Approval of Reserved Matters

Reference: H05/0789/92

Description: Erection of bungalow

Location : Fleet Road Fleet Hargate
Spalding Lincs

PROPOSED BUNGALOW WITH GARAGE
AND VEHICULAR ACCESS
FLEET ROAD, FLEET HARGATE,
for MR S WILES.

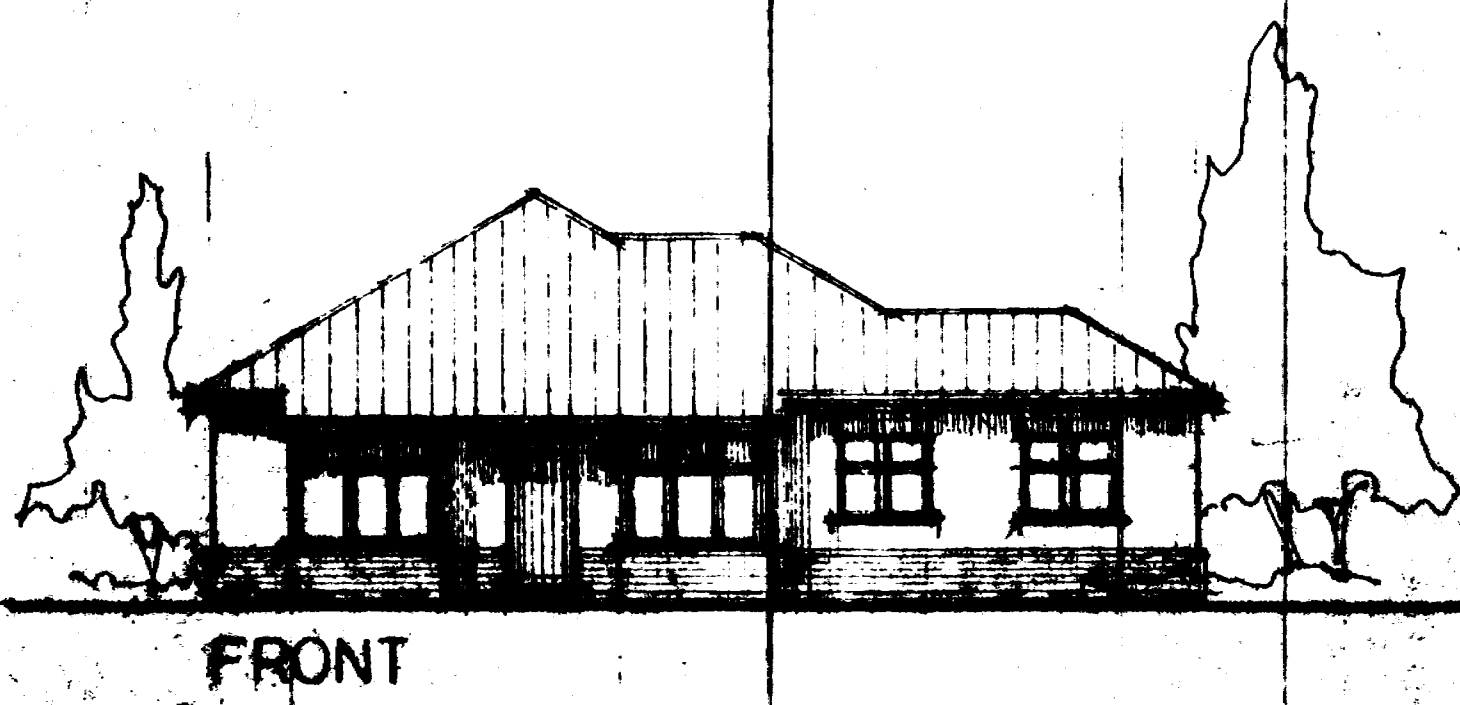
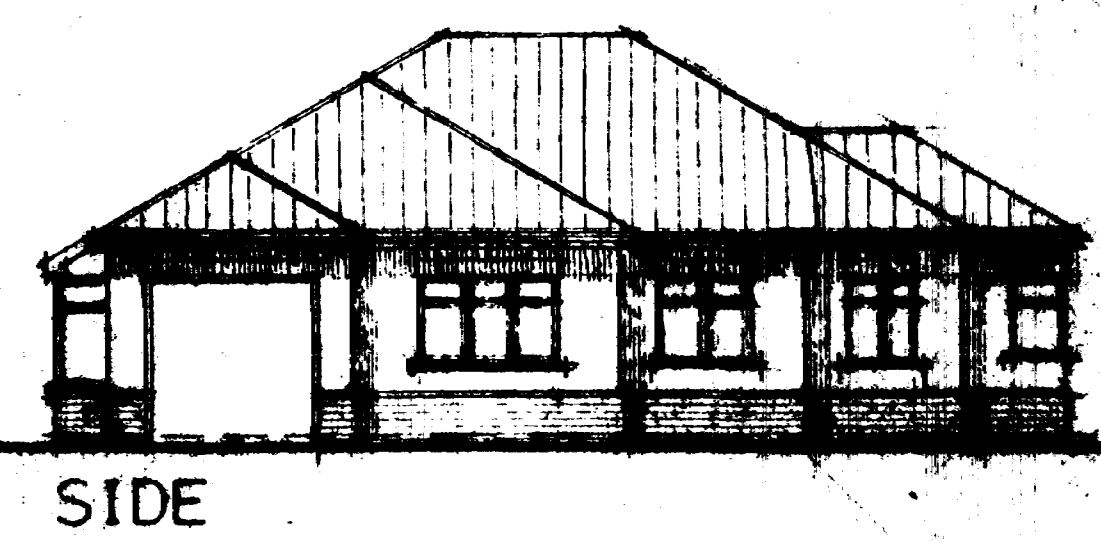
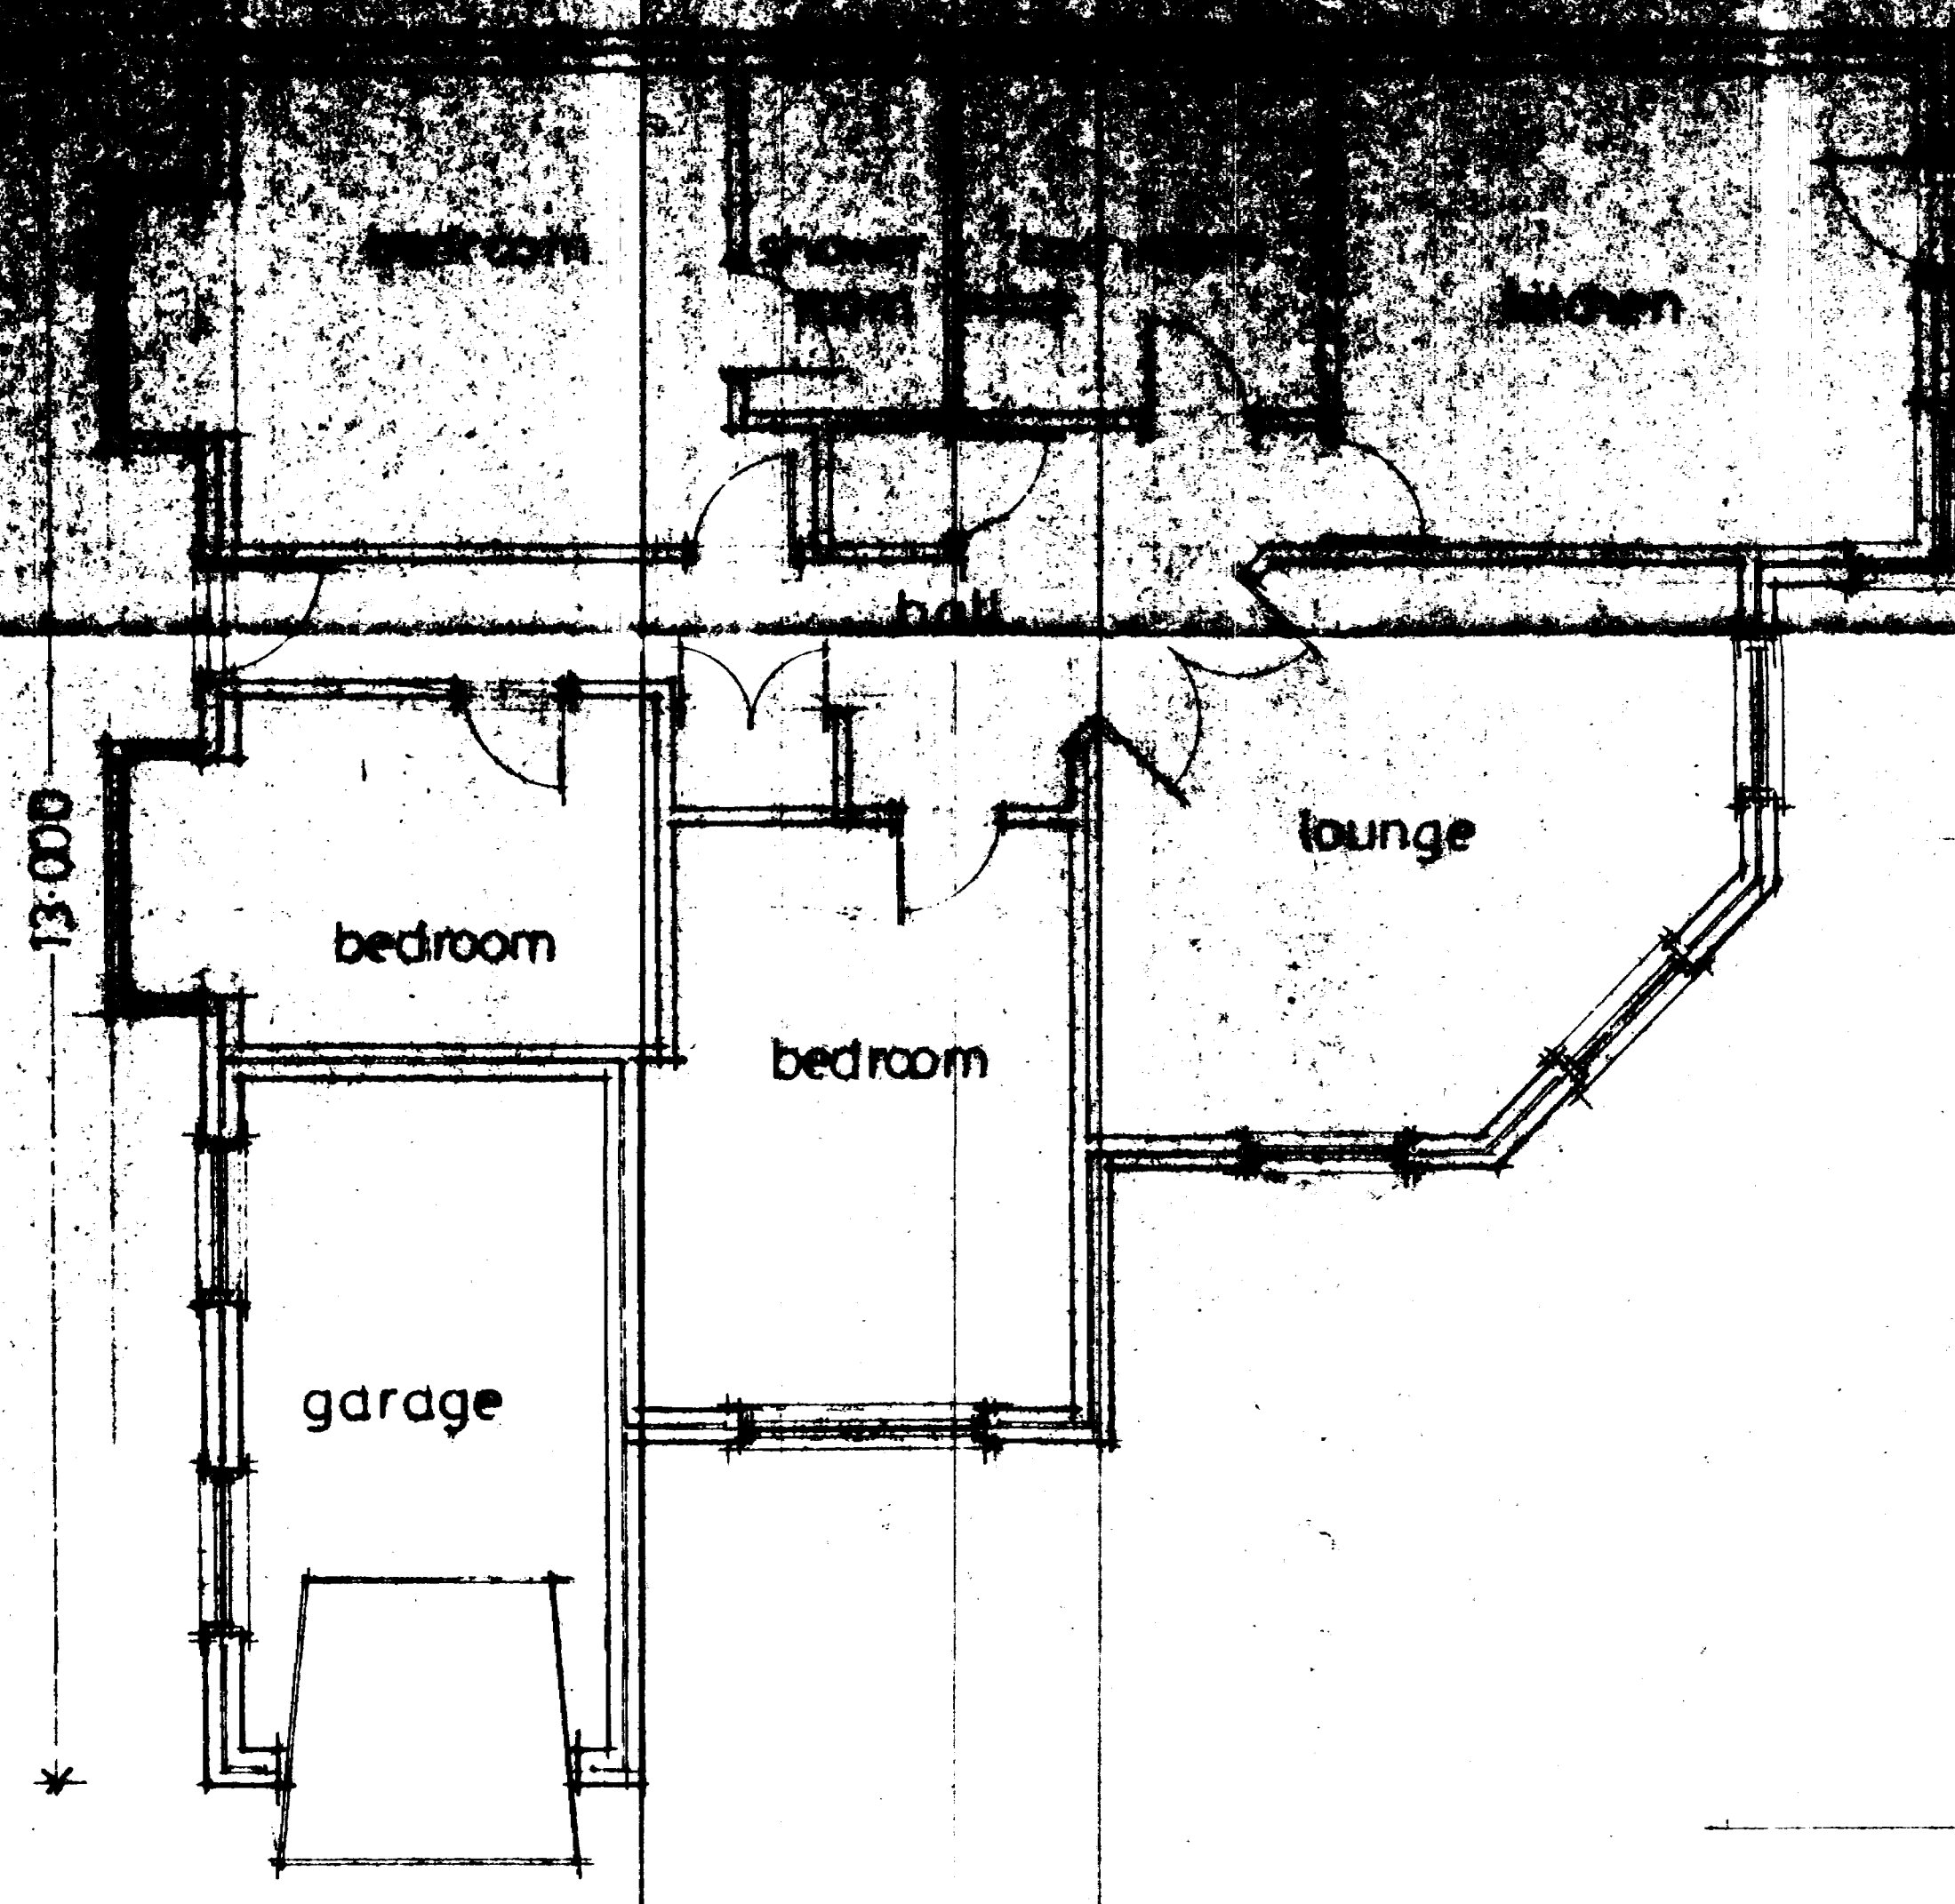
With reference to the above application could you please specify the proposed facing bricks and roofing tiles.

Could you also please specify the location and species of shrubs and trees to be planted in pursuance of the requirement to provide landscaping. These planting details should be shown on a copy of the site layout plan.

BRICK - BUTTERFLY MASONRY
TILE - SANDWICH CEMENT
SLATE (BROWN).

1. Cornus stolonifera 'Flaviramea'
2. Pyracantha 'Orange Glow'
3. Cornus alba 'Sibirica'

As agreed with the WILES.
13/10/92
